Installation Instructions

WR17X10424 - Bucket & Cover Assembly Display

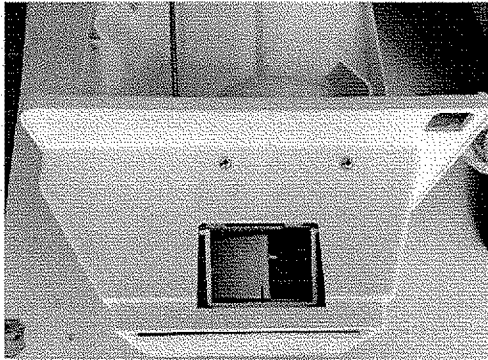
When a recent change was made to Bucket & Cover Assembly Display WR17X10424 to use Cover 162D1305P002 instead of specified Cover 187D1768P001, interference with the Freezer Door closure was inadvertently introduced. To eliminate that interference, the Cover provided with the new Bucket Assembly must be removed, discarded and replaced by the Cover on the assembly being replaced.

Cover to be removed and discarded
162D1305P002

Original Cover 187D1768P001

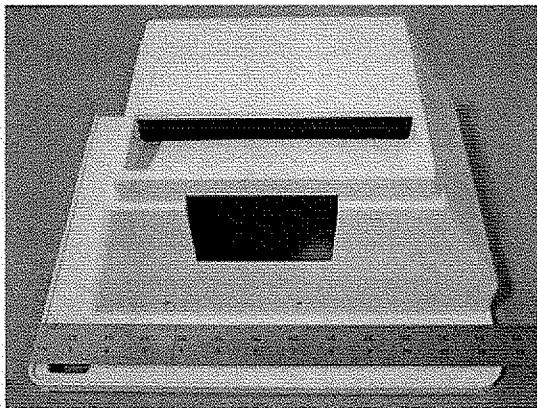
Two screws are located on the bottom of the Cover.

The Cover is easily removed from the assembly by removing four mounting screws. Those screw locations are the same on both Covers and shown in the photos below.

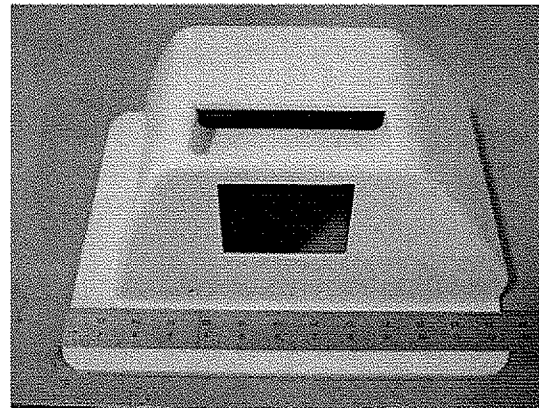
Two screws are located inside the Bucket, behind the Cover.
